RE: TEDS Exception from Minimum Cul-de-Sac length at 2220 Broadway

DESIGN EXCEPTION #DE16-02

RE: Exception from Maximum Cul-de-Sac Length at 2220 Broadway

**RE: Traffic Engineering Design Standards (TEDS) Exception
Section 5.1.3, Cul-De-Sac Length
Residential Subdivision, 2220 Broadway**

EXHIBIT 2

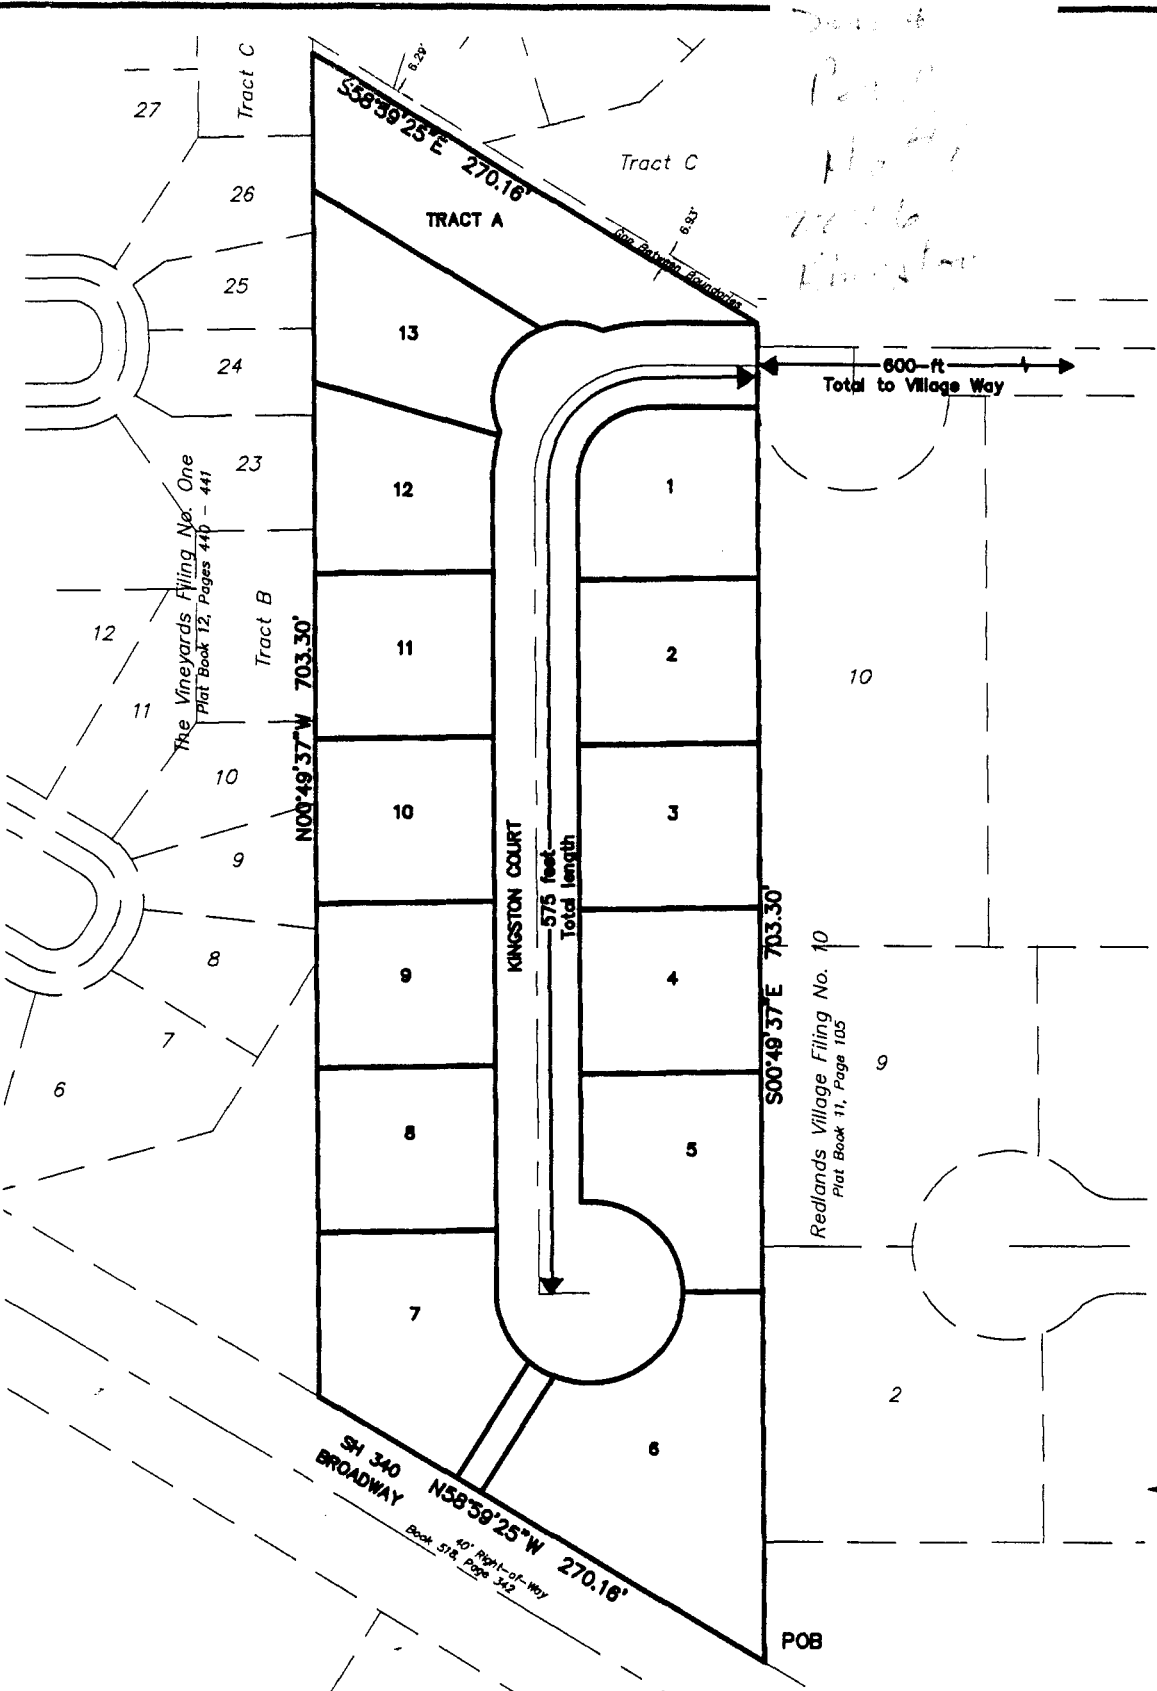
Because the proposed project will not be accessed from any other street, the project will extend Kingston Road as a cul-de-sac into the site. The proposed length of the cul-de-sac extending into the site is 575 feet, resulting in a total cul-de-sac length from Village Way of 1175 feet. Exhibit 2 shows the proposed layout of the subdivision.

Item 4: The letter continues stating that a 90-degree turn would compromise emergency access. The preliminary design shown on the exhibits submitted with the original exception letter do not show a 90-degree intersection. The turn is designed to an acceptable centerline radius and 'bulb-out' that have been routinely approved by City Development Engineering. In addition, Eric Hahn, City Development Engineer stated in the June 10 General Meeting that a TEDS exception is not required for this type of turn, presumably because these types of turns have been accepted in the past.

EXHIBIT 3

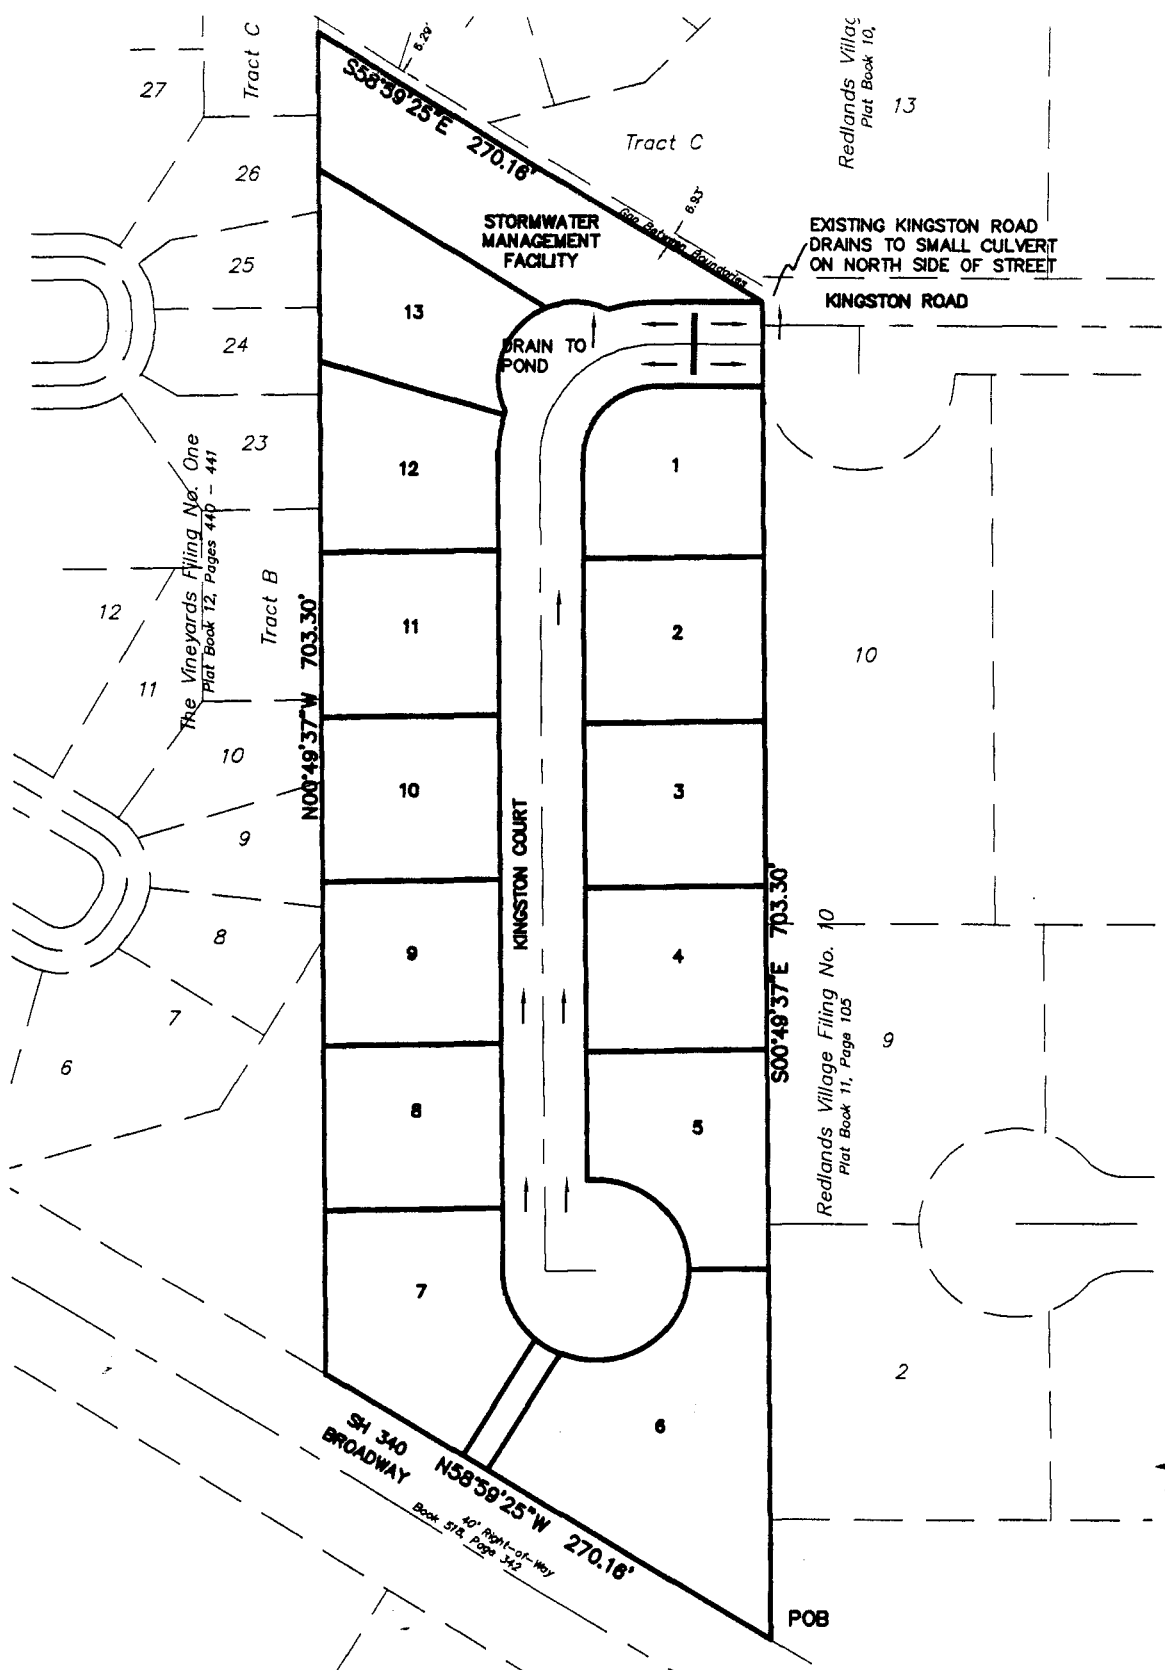
3. Surface drainage of the cul-de-sac must be conveyed towards the intersecting street, if possible, and if not possible a drainage easement shall be provided leading out of the cul-de-sac.
The existing Kingston Road actually slopes to the west, towards the proposed project and drains by way of an existing 6-inch culvert to the north. The proposed project will not drain to the same location, but will drain to a stormwater management facility located at the north end of the project. Please see Exhibit 3.

- Item 3: The neighbor's state that there is a drainage problem at the end of Kingston Road and that, because the proposed project will add to the problem. Clearly the neighbor's are correct in stating that there is a drainage problem at the end of Kingston Road. However, the letter is incorrect in stating that the proposed project will add to the problem. The original exception letter specifies that the project will not drain to the end of existing Kingston Road where the problems exist, but will drain to a project-specific stormwater management facility on the north side of the property. In addition, the Preliminary Plan and Final Plan applications that will be submitted to the Community Development Department will address drainage in greater detail.

3. Drainage of the new development and the flow off the west end of existing Kingston Road will have to adequately handled by this development under other portions of the review process.

EXHIBIT 4

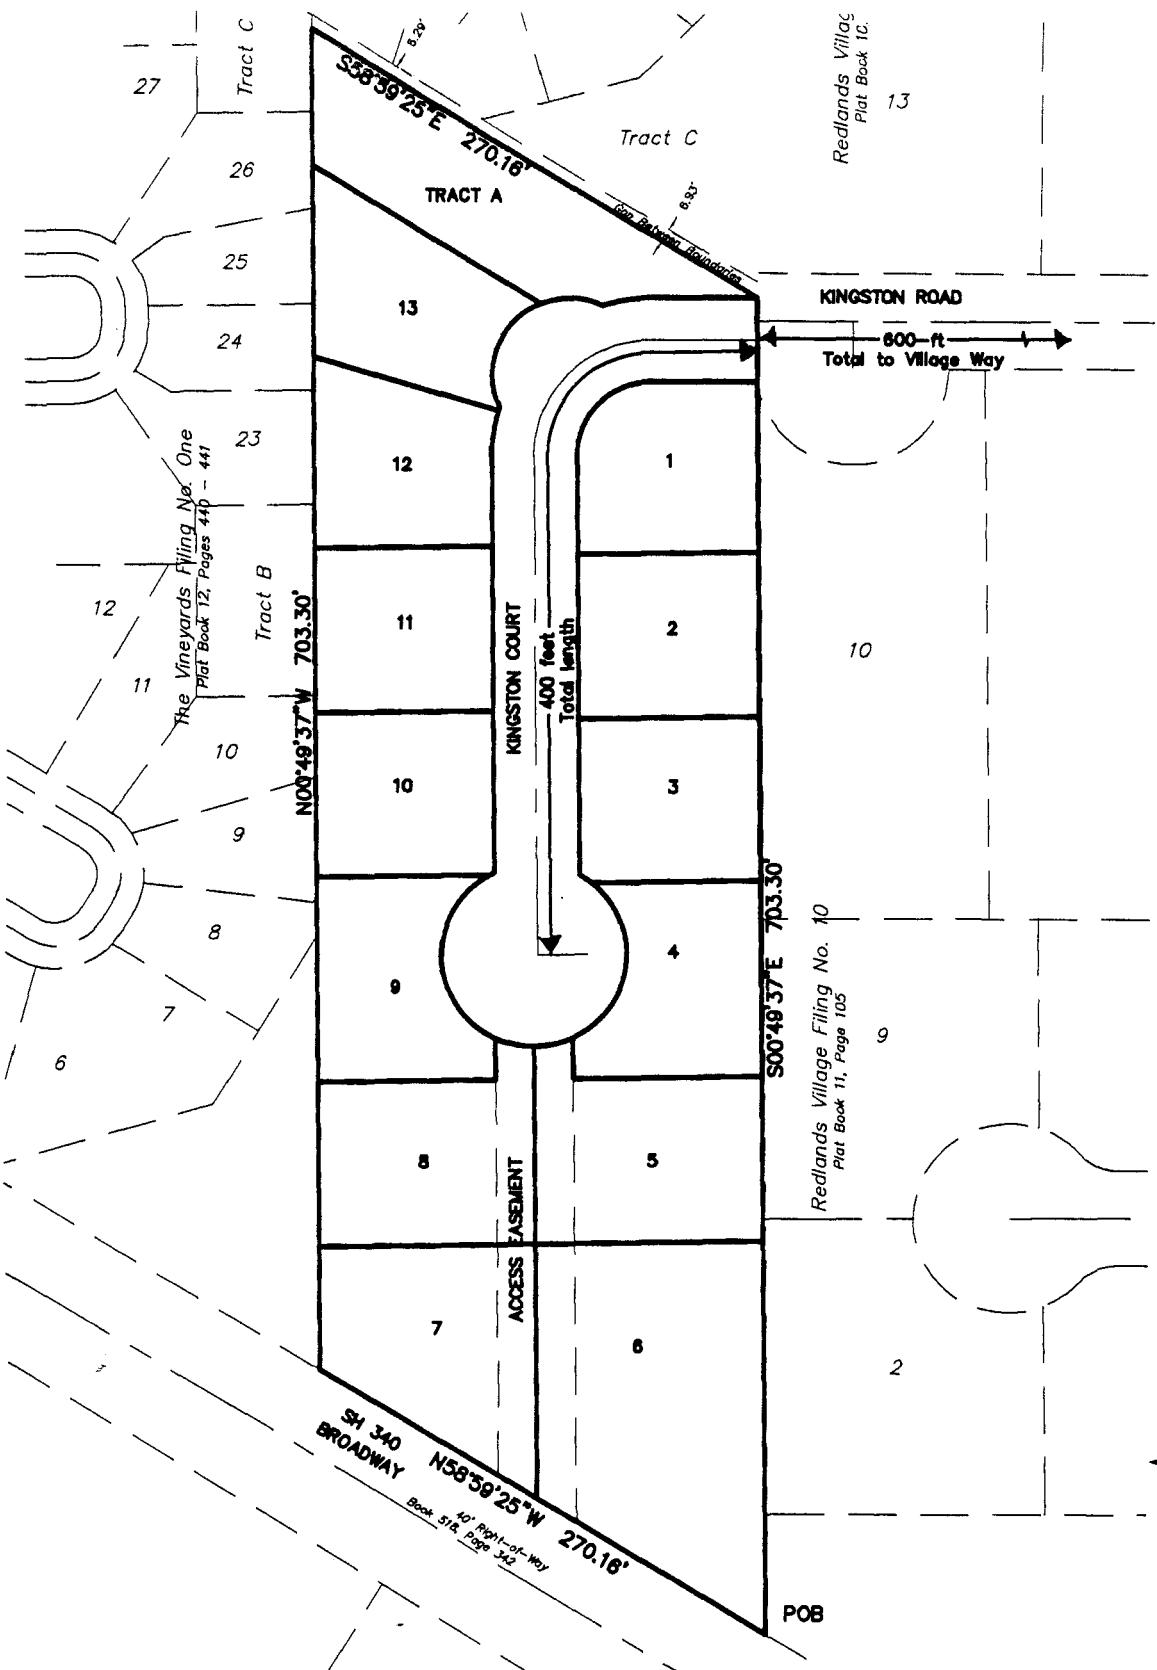
6. 13 lots seems to be achievable by manipulating flag lots and shared driveways without a TEDS exception, if necessary, but the results would be no better than the proposed plan.

- B) *Shorten the cul-de-sac to the 1000-foot limit:
Exhibit 4 shows a possible layout for a cul-de-sac length limited to 1000 feet. The result is that the layout has 4 flag lots if the proposed number of lots of 13 is retained. In addition, according to the City of Grand Junction Zoning and Development Code, Section 6.7.D.2b limits the amount of flag lots in a subdivision to 15%, or less than 2 flag lots. The layout shows 4 flag lots, or 31%, which is far above the 15% limit. In addition, the same section states that no more than two flag lots can be contiguous. The layout shows that 4 flag lots are contiguous. The developer feels that this layout is a poor design and will not be marketable and therefore would not proceed with the project.*

EXHIBIT 5

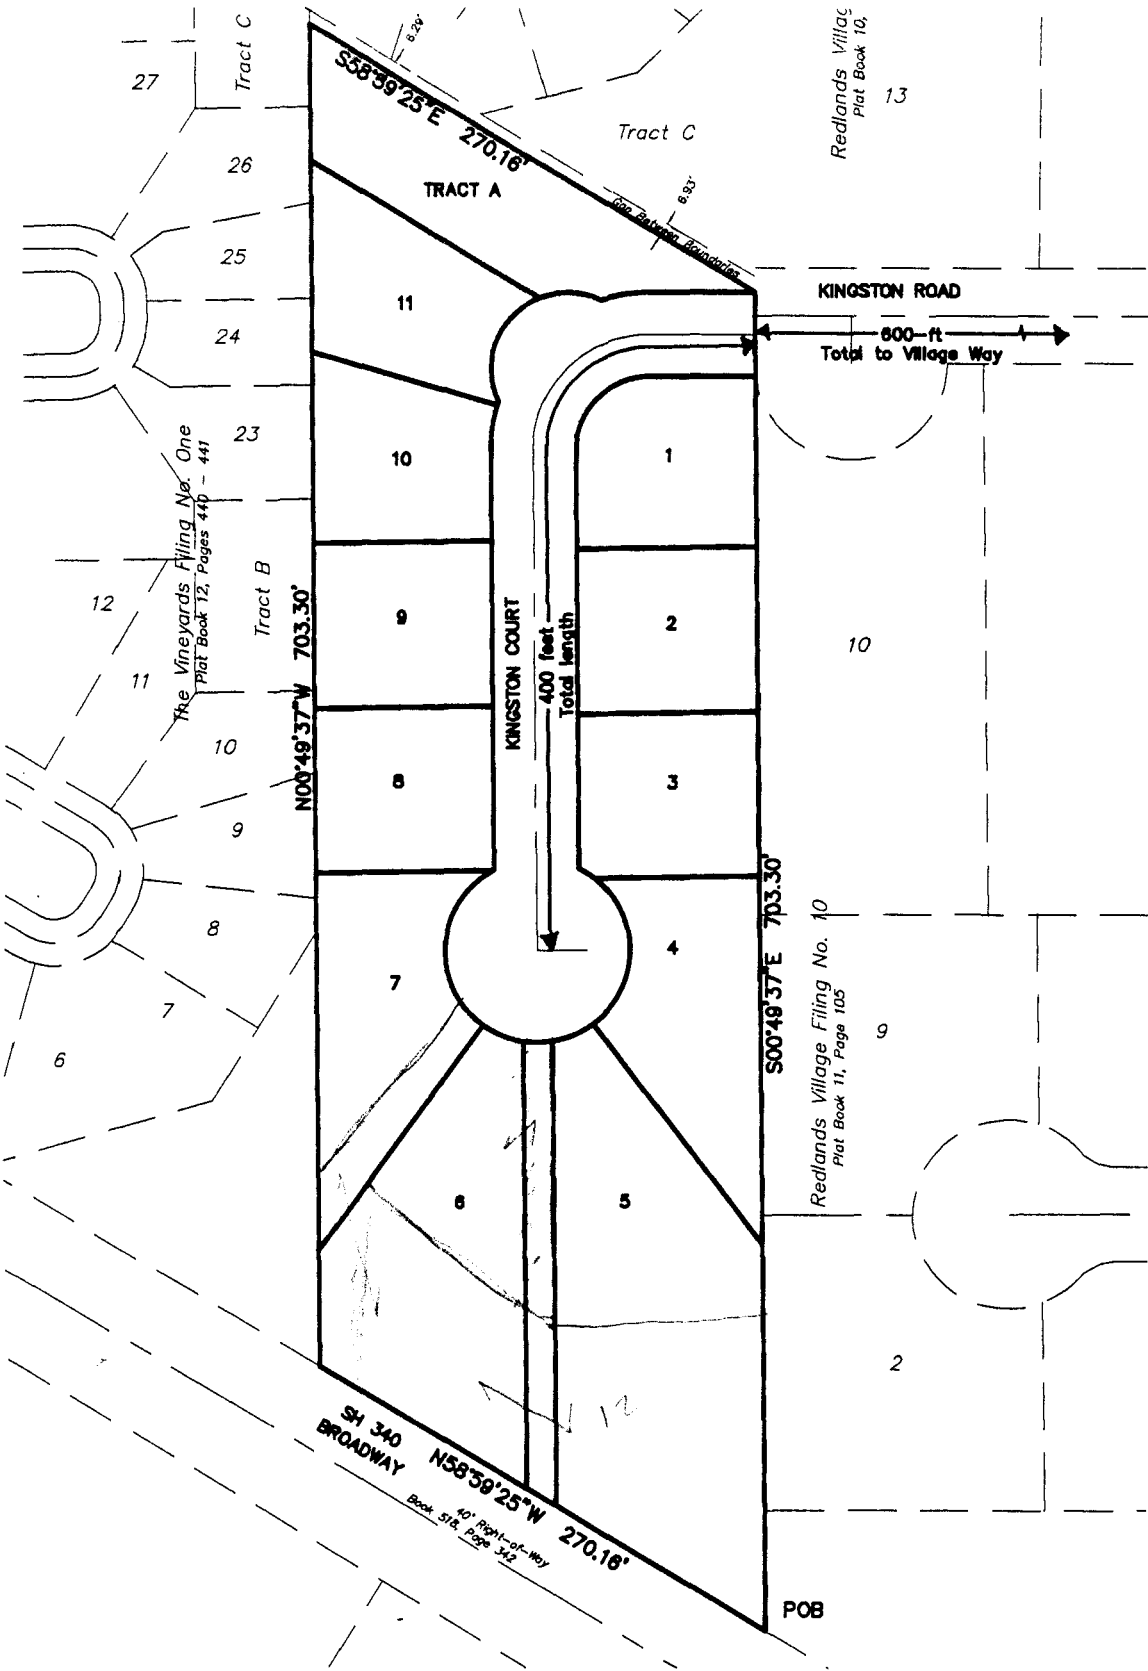
- C) *Shorten the cul-de-sac to 1000 feet and reduce the number of lots:
Exhibit 5 shows a possible layout of the subdivision with the 1000-foot cul-de-sac, 11 Lots and eliminates the flag lots. This alternative would meet all of the requirements of the TEDS manual.*
